DEVELOPMENT NO.:	22029247
APPLICANT:	Keith Fancsali Tammy Fancsali
ADDRESS:	UNIT 1-3,38 ADELPHI CR GLENELG NORTH SA 5045
NATURE OF DEVELOPMENT:	Two storey detached dwelling comprising an undercroft garage, swimming pool and deck
ZONING INFORMATION:	Zones: <ul style="list-style-type: none"> • General Neighbourhood Overlays: <ul style="list-style-type: none"> • Aircraft Noise Exposure • Airport Building Heights (Regulated) • Affordable Housing • Building Near Airfields • Hazards (Flooding - General) • Prescribed Wells Area • Regulated and Significant Tree • Stormwater Management • Traffic Generating Development • Urban Tree Canopy
LODGEMENT DATE:	1 Sep 2022
RELEVANT AUTHORITY:	Assessment Panel at City of Holdfast Bay
PLANNING & DESIGN CODE VERSION:	2022.15
CATEGORY OF DEVELOPMENT:	Code Assessed - Performance Assessed
NOTIFICATION:	Yes
RECOMMENDING OFFICER:	Dean Spasic Development Officer - Planning

DETAILED DESCRIPTION OF PROPOSAL:

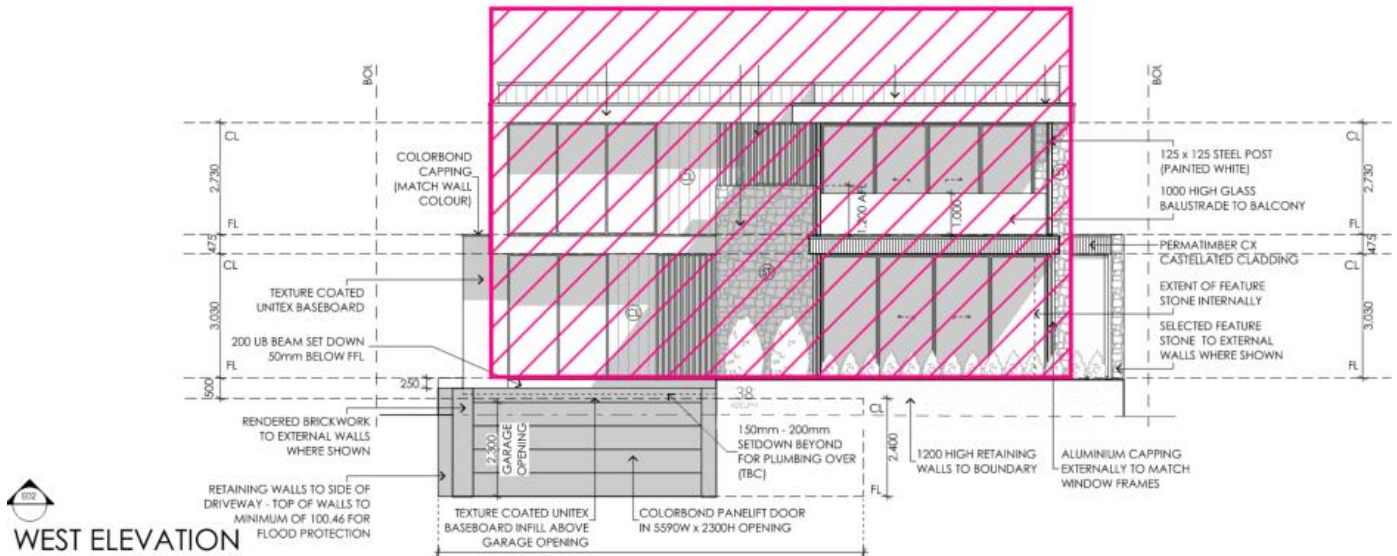
The proposed building has two levels and a total height of 8.4 metres above the ground level. The wall height is between 7.2 metres in height above the footing, hence the public notification. The undercroft is 2.1 metres below the natural ground level. Visually, the building presents well and is consistent with the modern architecture found in the surrounding locality. The building has a flat roof, large balconies and openings and walls have various finishes including rendered brickwork, vertical profile cladding and feature stone work.

On balance, the total wall height is not considered to be a significant departure from the Design Code, in that the undercroft is below natural ground, the total building height is below the maximum allowed by the Zone and therefore the overall mass and scale of the building remains within that anticipated by the Zone.

For context, the illustration below demonstrates an overlay of the scale and building mass (9m tall building above footing) that would satisfy the Design Code, which would sit higher and present more intrusively than the building proposed. This illustration helps demonstrate that the undercroft component is not a feature that can be considered unreasonable in the context of what the Zone allows for:

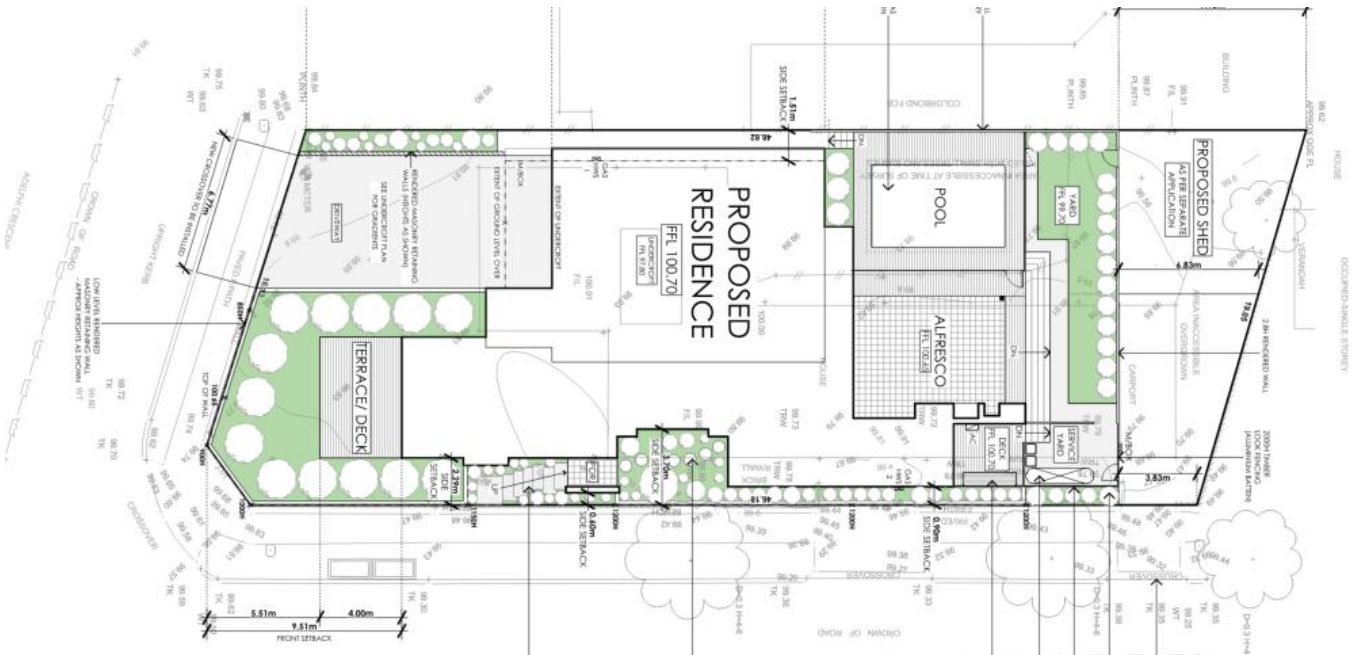
Building setback 7.9 metres plus from front boundary, which is generally in-line with the northern adjacent building, which is the only other neighbouring building that faces the same street.

At the ground level, the building wall is 4 metres high and setback 1.5 metres from the northern side boundary. A minimum setback of 1.2 metres is required here.

At the upper level, the building wall 6.7 metres high setback 2.1 metres+ from the northern side boundary, which meets the minimum required by the Design Code.

Building wall setback 900mm+ from the secondary street boundary, which satisfies the minimum requirement of the Design Code.

The building is setback 6 metres+ from the rear boundary, which satisfies the minimum requirement of the Design Code.
